Access Compliance Report

Public Rights-of-Way

(Curb Ramps)

Intersection ID: 15094	Main Street: ALBEMARLE_RD	Cross Street: REDDMAN_RD	Location: NE
ADA ID: 1E601451CD7A	Ramp Type: Perp	Initial Pass/Fail: Fail	Overall Compliance: No
Severity Score: 33.75			
Codes/Mitigation Info/Possible Solution		Field Measurements/Component Compliance

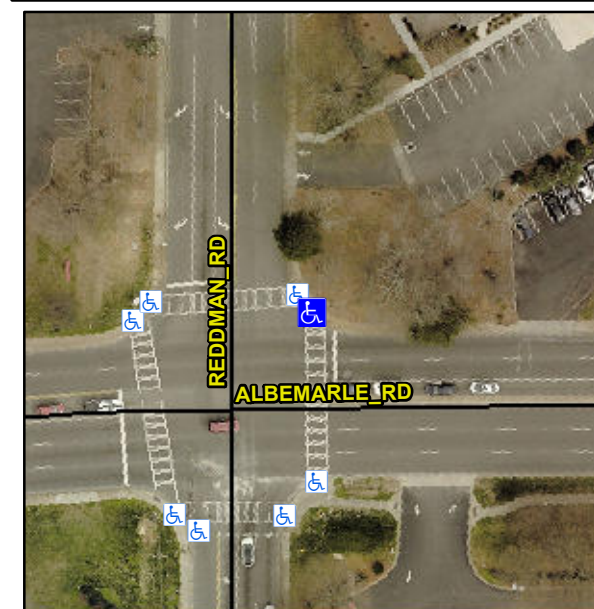
Not Found, R304.5.1, R304.2.2, R304.5.3

Compliance	Description	Data	Compliance	Description	Data
N/A	Ramp Length (in)	60.0	No	Ramp Slope (%)	9.7
No	Ramp Width (in)	41.0	No	Ramp XSlope (%)	6.9
N/A	Flare Type LT	N/A	N/A	Flare Type RT	N/A
N/A	Flare Slope LT (%)	N/A	N/A	Flare Slope RT (%)	N/A
N/A	Flare Traversable LT?	N/A	N/A	Flare Traversable RT?	N/A
N/A	Landing Length (in)	N/A	N/A	DWS Provided?	N/A
N/A	Landing Width (in)	N/A	N/A	DWS Contrast?	N/A
N/A	Landing Slope (%)	N/A	N/A	DWS Length (in)	N/A
N/A	Landing X Slope (%)	N/A	N/A	DWS Full Width?	N/A
N/A	Landing Curb? (Y/N)	N/A	N/A	DWS Offset (in)	N/A
N/A	Shared Landing?	N/A			
N/A	Gutter Ponding?	N/A	N/A	Gutter Slope (%)	N/A
N/A	Gutter Lip Ht (in)	N/A	N/A	Gutter X Slope (%)	N/A
N/A	Painted X Walk1?	Yes	N/A	Painted X Walk2?	N/A
	X Walk 1 Direction	To S		X Walk 2 Direction	N/A
N/A	X Walk 1 Width (in)	110.0	N/A	X Walk 2 Width (in)	N/A
	X Walk 1 Slope (%)	2.8		X Walk 2 Slope (%)	N/A
	X Walk 1 X Slope (%)	4.5		X Walk 2 X Slope (%)	N/A

Remove & Replace Entire Ramp.
